Change Order (CO) No. 002

Owner: City of Snoqualmie
 Project: WRF Phase 3 Improvements
 Project No: SNQ 22-0040
 Engineer: **RH2 Engineering, Inc.**
 Contractor: Prospect Construction, Inc.

Re: Snoqualmie WRF Phase 3
PCO 31 - RFI N - RFI N Digester Aeration Piping Mods Pricing
PCO 31 – additional Work Request T&M

CITY OF SNOQUALMIE
WATER RECLAMATION FACILITY
PHASE 3 IMPROVEMENTS
DIGESTER MECHANICAL
RETROFIT PLAN

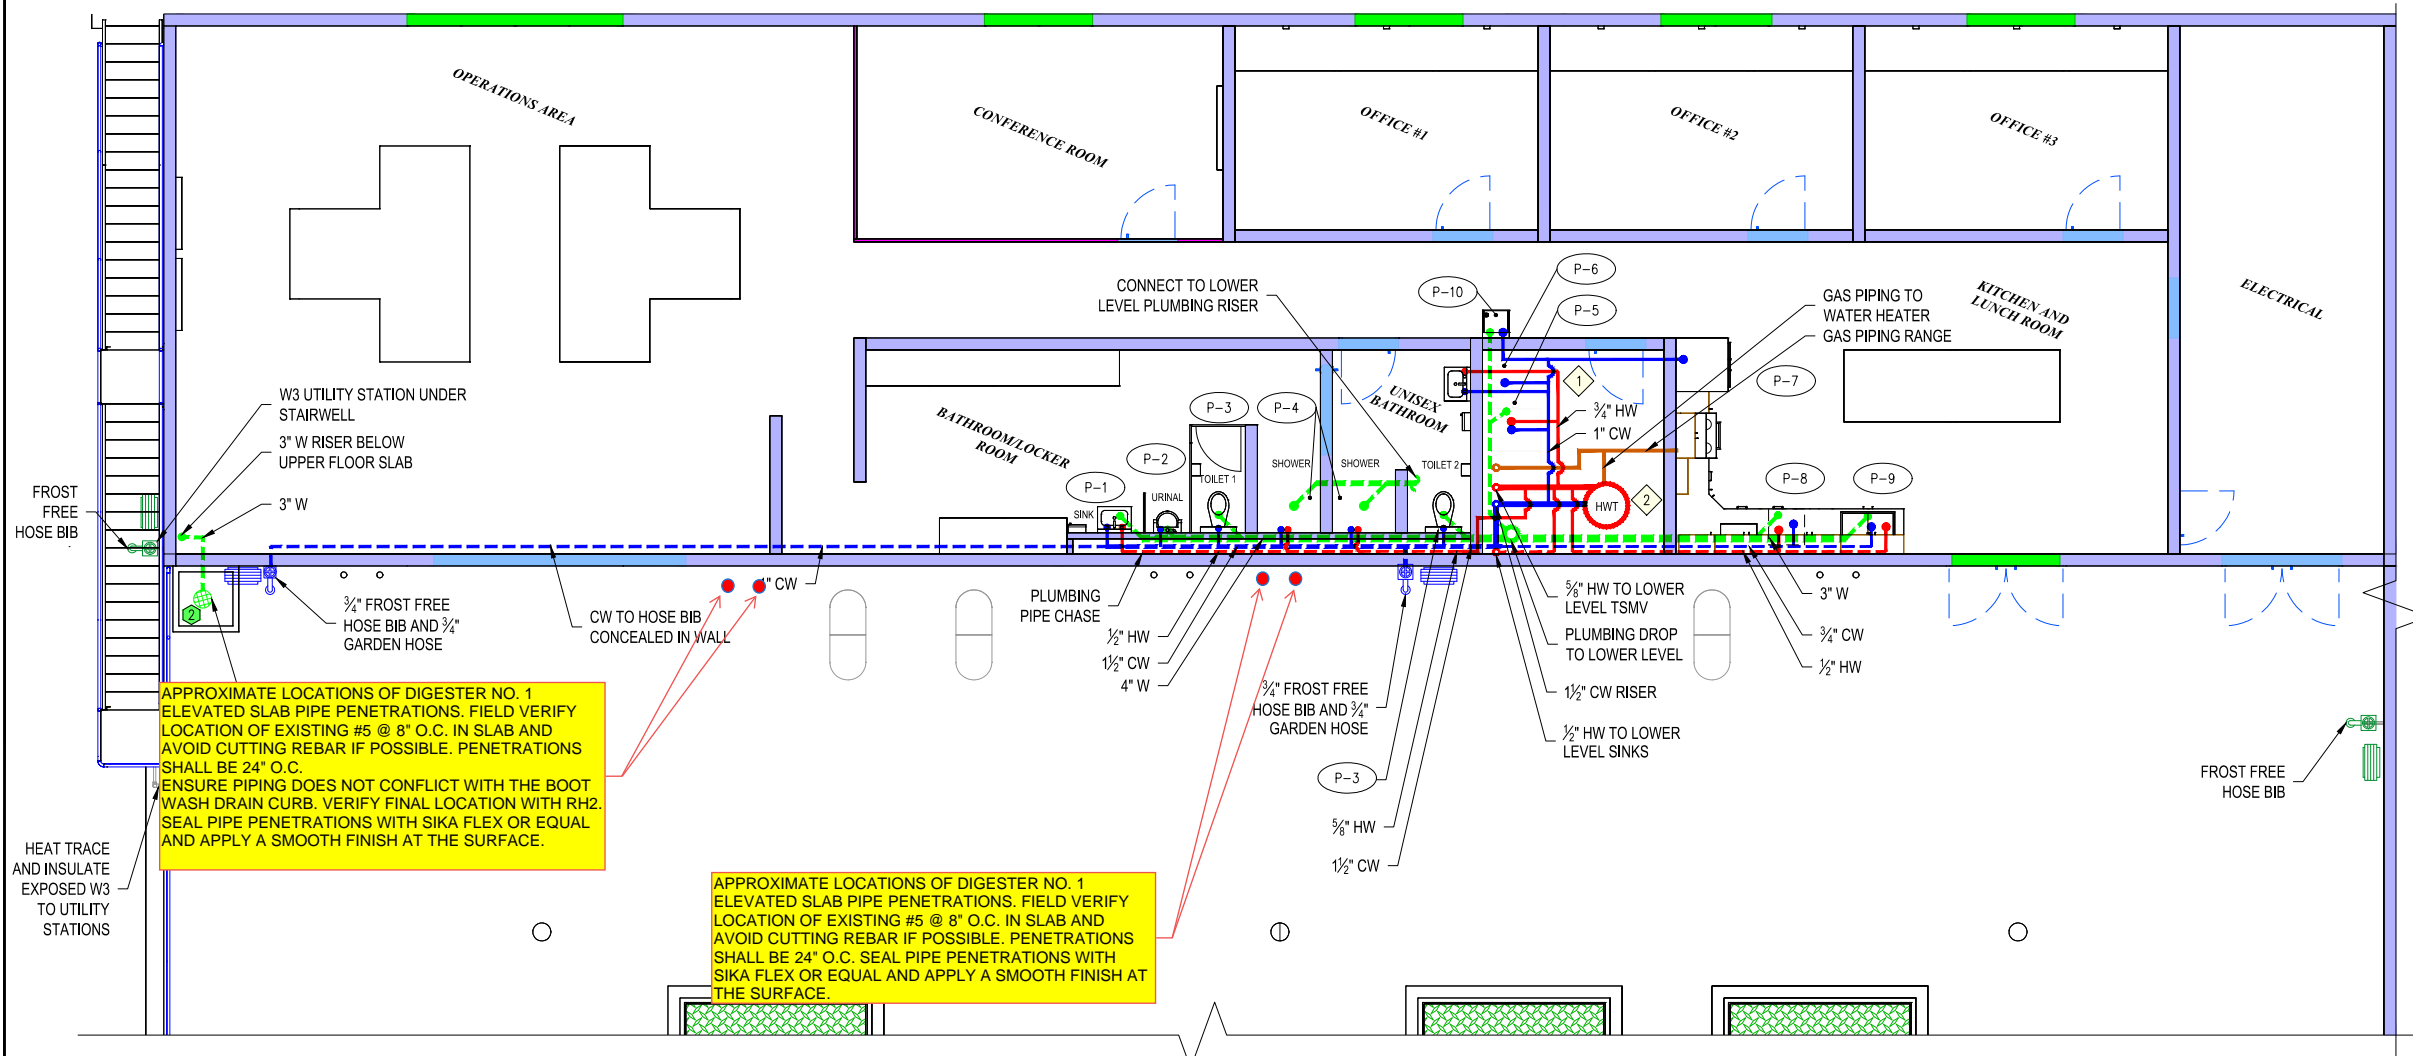
APPROXIMATE LOCATIONS OF DIGESTER NO. 1 ELEVATED SLAB PIPE PENETRATIONS. FIELD VERIFY LOCATION OF EXISTING #5 @ 8" O.C. IN SLAB AND AVOID CUTTING REBAR IF POSSIBLE. PENETRATIONS SHALL BE 24" O.C. ENSURE PIPING DOES NOT CONFLICT WITH THE BOOT WASH DRAIN CURB. VERIFY FINAL LOCATION WITH RH2. SEAL PIPE PENETRATIONS WITH SIKA FLEX OR EQUAL AND APPLY A SMOOTH FINISH AT THE SURFACE.

APPROXIMATE LOCATIONS OF DIGESTER NO. 1 ELEVATED SLAB PIPE PENETRATIONS. FIELD VERIFY LOCATION OF EXISTING #5 @ 8" O.C. IN SLAB AND AVOID CUTTING REBAR IF POSSIBLE. PENETRATIONS SHALL BE 24" O.C. SEAL PIPE PENETRATIONS WITH SIKA FLEX OR EQUAL AND APPLY A SMOOTH FINISH AT THE SURFACE.

AIR PIPE LOOP SCHEMATICS

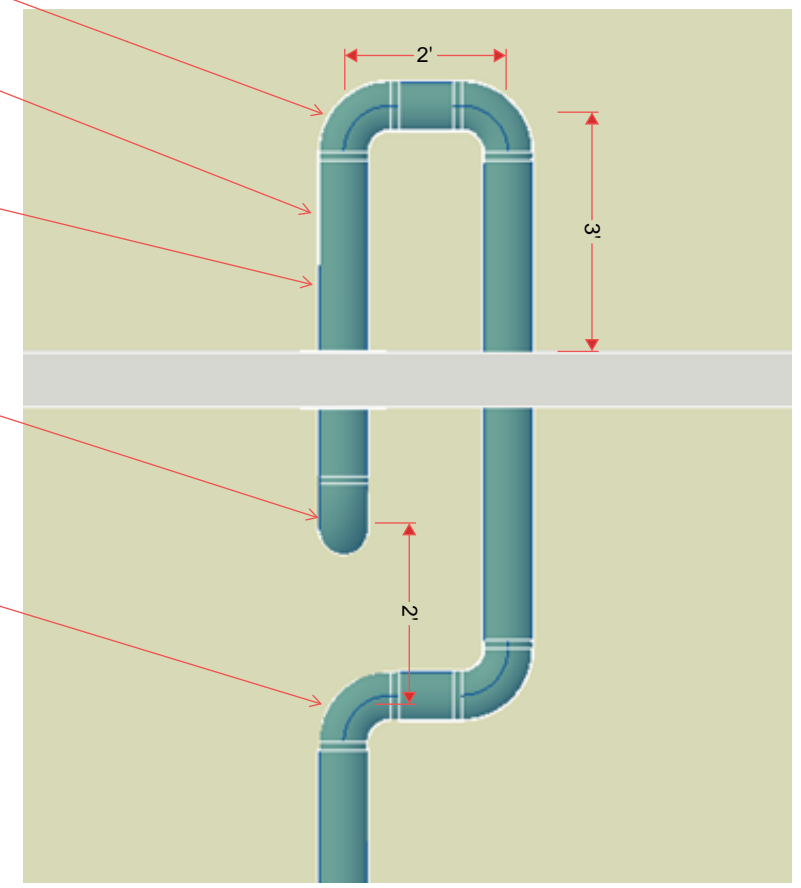
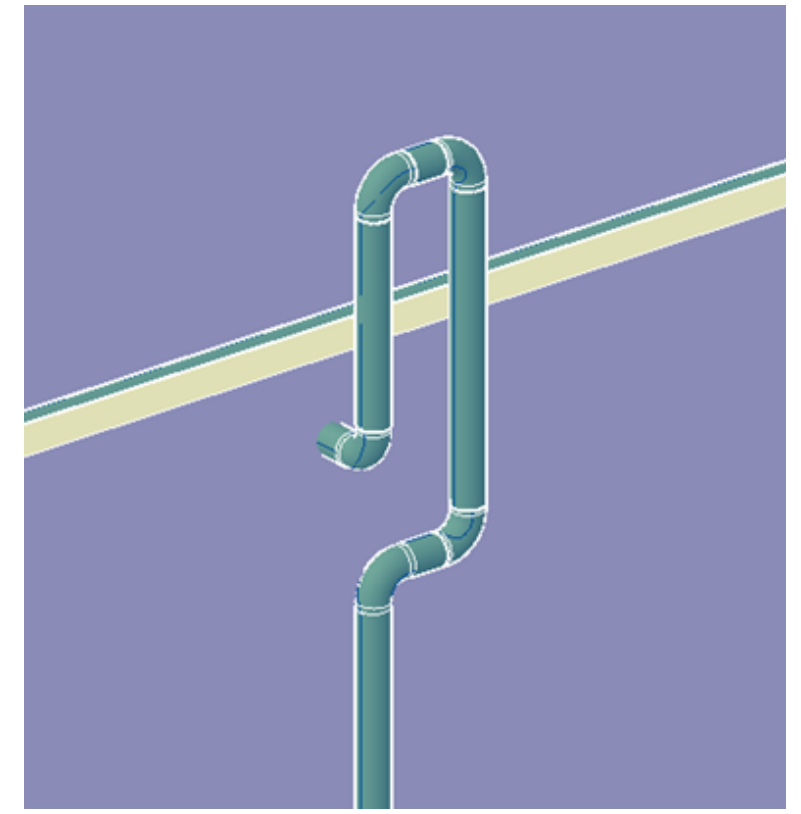
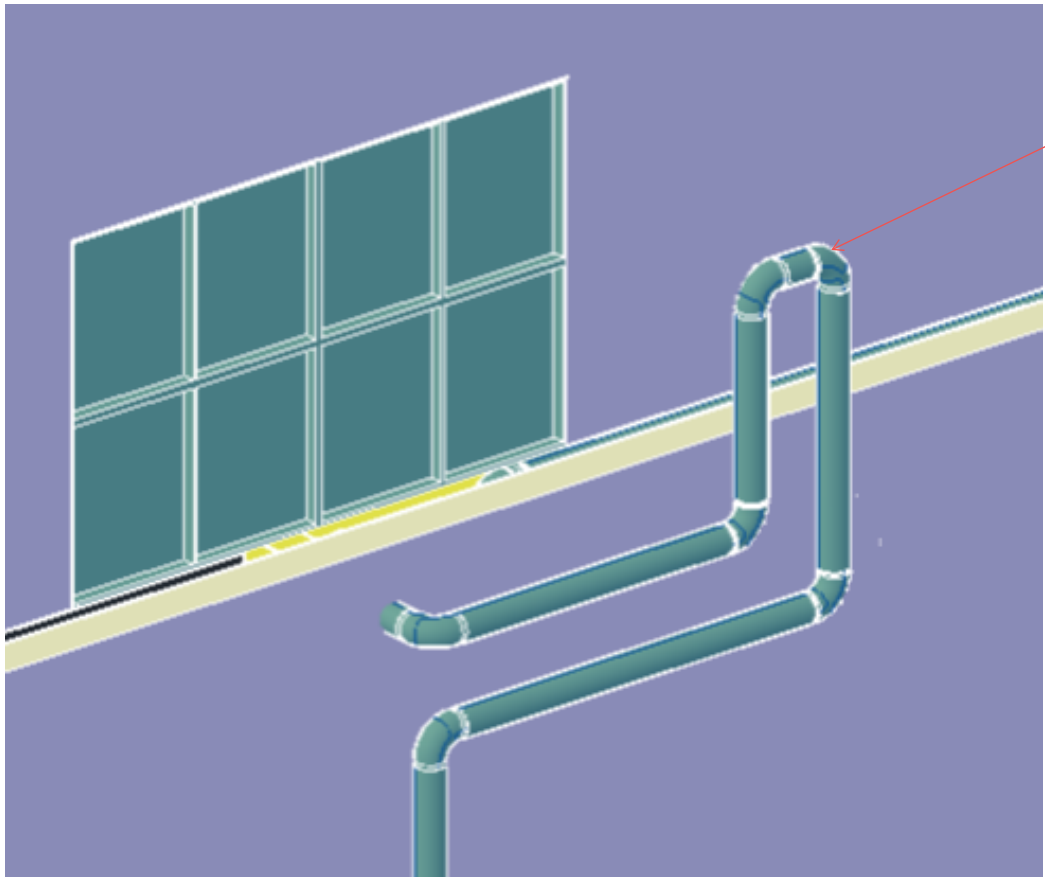
APPROXIMATE LOCATION OF OUTLET ON WALL. VERIFY AIR PIPE DOES NOT CONFLICT WITH OUTLET OR WITH PROCESS PIPING INSIDE DIGESTER NO. 1.

NO PIPE SUPPORTS SHALL BE ATTACHED TO THE METAL WALLS OF THE SOLIDS HANDLING BUILDING ABOVE THE ELEVATED SLAB.

WELD ALL NEW PIPES AND FITTINGS AND USE SAME MATERIAL AS EXISTING STEEL PIPE.

REMOVE EXTENTS OF EXISTING AIR PIPE NECESSARY TO ADD ADDITIONAL PIPING AND RECONNECT TO THE DOWNSTREAM AIR PIPE TOWARDS THE JET AERATION SYSTEM.
REUSE THE 90° BEND AT THE TOP OF THE DIGESTER AND ROTATE 180° AS SHOWN.

INSTALL PIPE SUPPORTS AS NEEDED TO PROVIDE A FULLY FUNCTIONAL, RIGID AND NON-SAGGING SYSTEM. PIPE SUPPORTS SHALL BE EPOXIED AND ANCHORED TO THE INTERIOR DIGESTER WALL.

WELD ALL NEW PIPES AND FITTINGS AND USE SAME MATERIAL AS EXISTING STEEL PIPE.

INSTALL PIPE SUPPORTS AS NEEDED TO PROVIDE A FULLY FUNCTIONAL, RIGID AND NON-SAGGING SYSTEM. PIPE SUPPORTS SHALL BE EPOXIED AND ANCHORED TO THE INTERIOR DIGESTER WALL.

REMOVE EXTENTS OF EXISTING AIR PIPE NECESSARY TO ADD ADDITIONAL PIPING AND RECONNECT TO THE DOWNSTREAM AIR PIPE TOWARDS THE JET AERATION SYSTEM.

REUSE THE 90° BEND AT THE TOP OF THE DIGESTER AND ROTATE 90° AS SHOWN.
